## HISTORIC AND DESIGN REVIEW COMMISSION

**HDRC CASE NO:** 2019-336  
**ADDRESS:** 405 GILLESPIE  
**LEGAL DESCRIPTION:** NCB 1745 BLK 8 LOT S 51.5 FT OF N 103 FT OF 5 E IRR 7FT OF MID PART OF 5 & 6  
**ZONING:** R-6, H  
**CITY COUNCIL DIST.:** 1  
**DISTRICT:** Tobin Hill Historic District  
**APPLICANT:** Jake Forshpan/FORSHPAN JAKE B & FORSHPAN SHARON K  
**OWNER:** Jake Forshpan/FORSHPAN JAKE B & FORSHPAN SHARON K  
**TYPE OF WORK:** Side porch modifications  
**APPLICATION RECEIVED:** June 03, 2019  
**60-DAY REVIEW:** August 02, 2019  
**CASE MANAGER:** Huy Pham

The applicant is requesting a Certificate of Appropriateness for approval to remove the existing side porch to reconstruct a new enclosed side porch with similar architectural details.

Side elevation

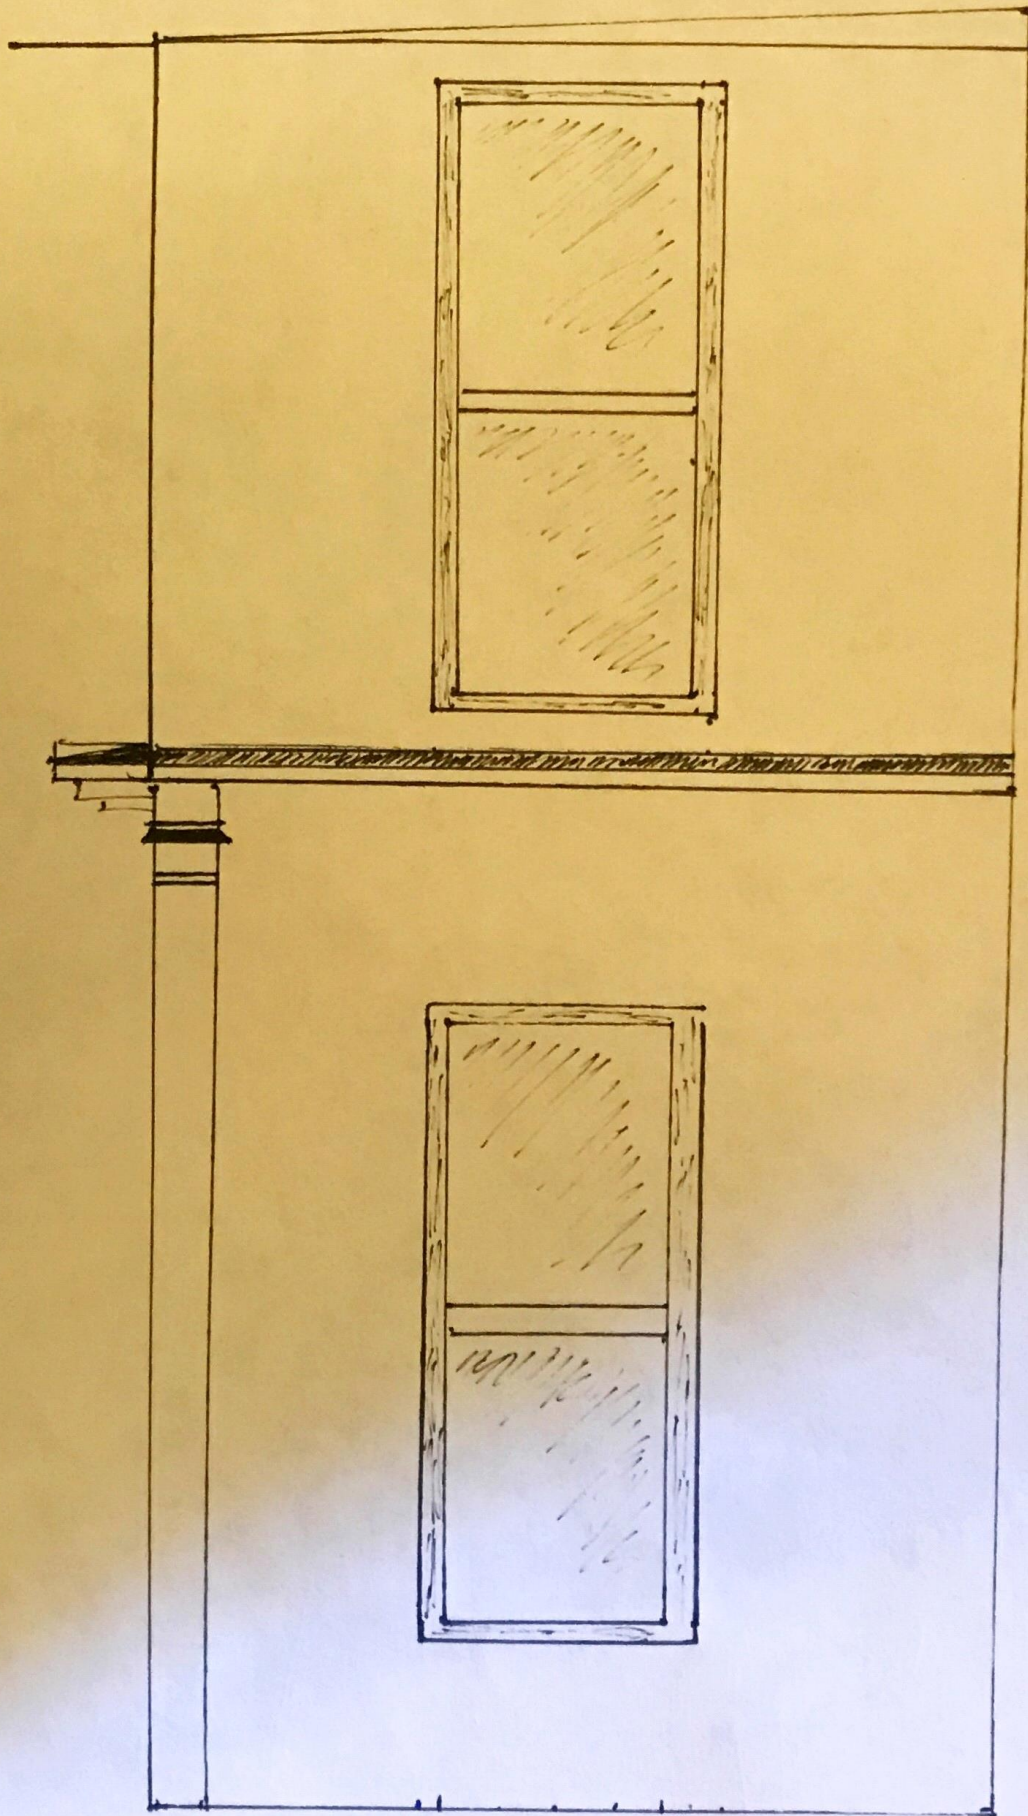
- d. **MODIFICATION** – The applicant has proposed to reconstruct the side porch as an enclosed addition with matching wood windows and lap siding to match the primary structure. The reconstruction requires relocating the original inset location of the columns by 16 inches each to meet flush at the corner of the balcony. The proposed side porch will also feature a matching fascia between the first and second floor matching the front façade detail. The original shed roof will remain in place and be used as a reference for the reconstructed footprint.

- e. **ENCLOSURE** – Per the Guidelines for Exterior Maintenance and Alterations 7.B.ii., one should refrain from enclosing side and rear porches, particularly when connected to the main porch or balcony. Additionally, the guidelines note that original architectural details should not be obscured by any screening or enclosure materials and that alterations to side and rear porches should result in a space that functions. Enclosed side and rear porches should appear as porches. Staff finds that the enclosure of this side porch to be generally appropriate given that it is not connected to the main porch; however, staff finds that architectural elements such as the columns should not be removed or obscured and that the space should still function and be visually interpreted as a porch.

- f. **RECONSTRUCTION** - Additionally, per the Guidelines for Exterior Maintenance and Alterations 7.B.v. the reconstruction of porches, balconies, and porte-cocheres should be based on accurate evidence of the original, such as photographs. If no such evidence exists, the design should be based on the architectural style of the building and historic patterns on the block. Staff finds that photographic evidence does exist, and in-kind reconstruction should be considered prior to relocating original columns and enclosing open spaces with siding.

Staff does not recommend approval as proposed based on finding b through f. Staff recommends an in-kind reconstruction based photographic evidence to match in footprint and fenestration details. A first floor enclosure may be appropriate while the already screened second-floor balcony should be restored in-kind.

If the commission is compelled to approve the reconstruction as proposed including the relocation of porch columns, the installation of lap siding on the first and second floor, and the installation of wood windows and doors, staff recommends the following stipulations:

- i. The new siding should match the existing structure (117 profile).
- ii. The new wood windows should match the existing windows in size, type, configuration, material, form, appearance, and details including the standard stipulations: *Meeting rails that are no taller than 1.25” and stiles no wider than 2.25”. White manufacturer’s color is not allowed, and color selection must be presented to staff. There should be a minimum of two inches in depth between the front face of the window trim and the front face of the top window sash. This must be accomplished by recessing the window sufficiently within the opening or with the installation of additional window trim to add thickness. Window trim must feature traditional dimensions and an architecturally appropriate sill detail. Window track components must be painted to match the window trim or concealed by a wood window screen set within the opening.*

- iii. The original columns and fascia details should be incorporated into the new side enclosed porch addition.

**405 GILLESPIE  
SAN ANTONIO, TX  
78212**

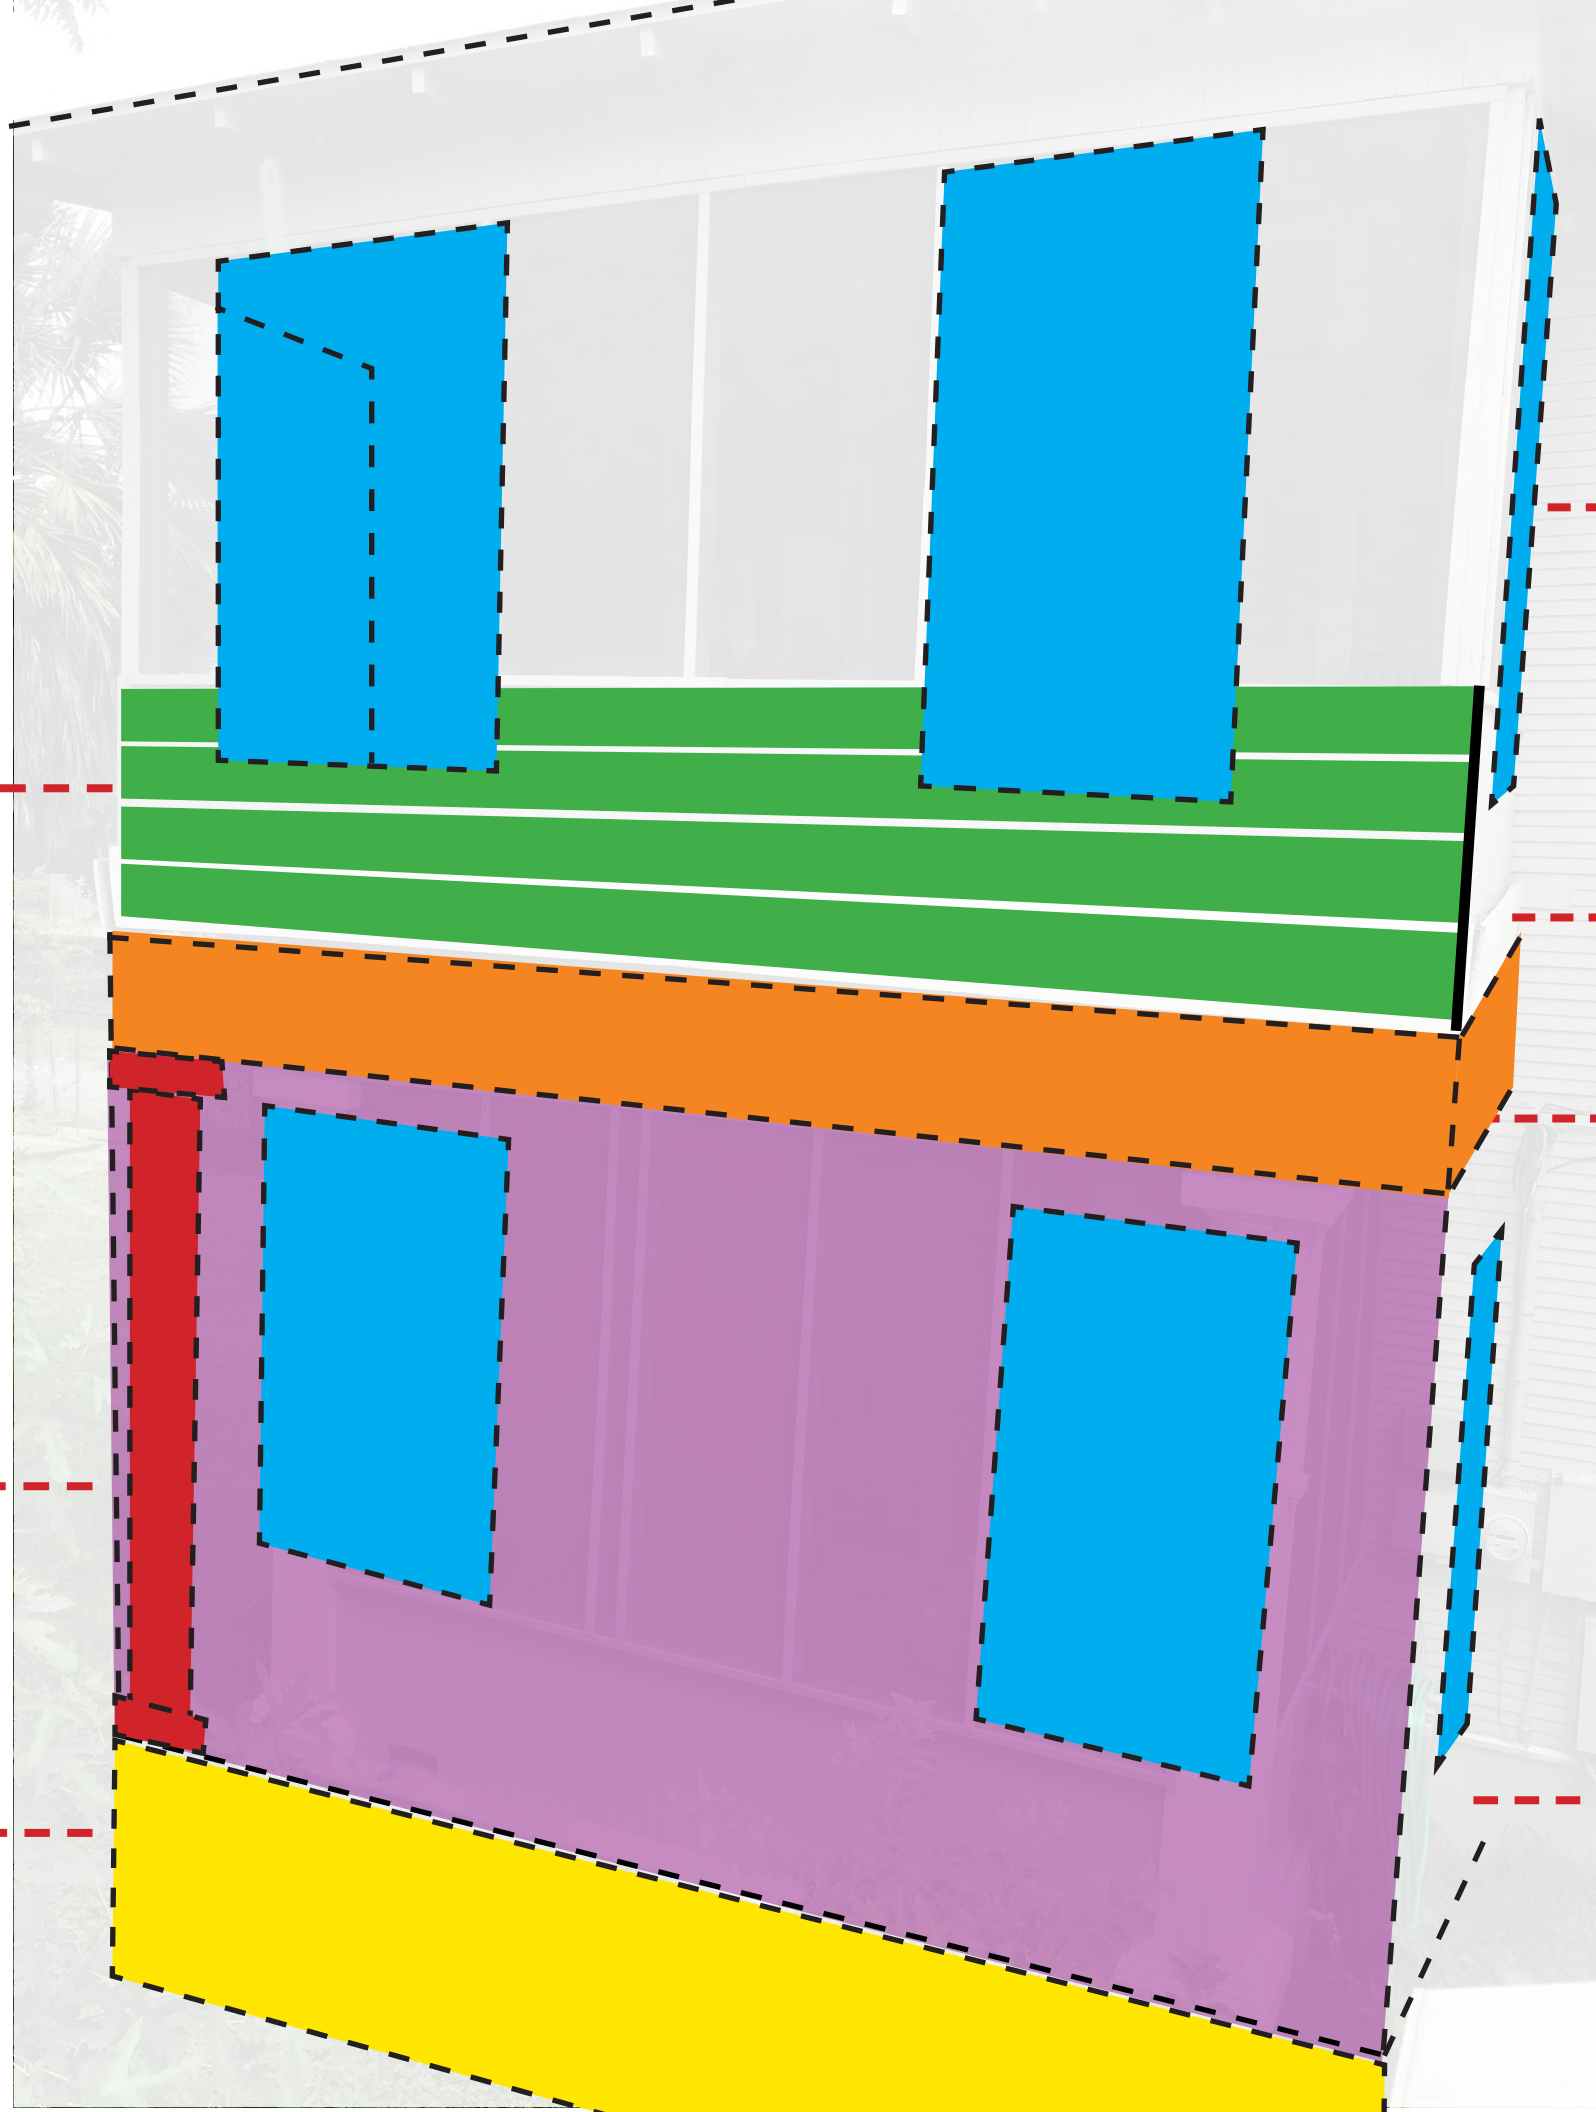
originals collumns moved  
to corners (16") post added  
inside for structural support  
(See collumn detail)
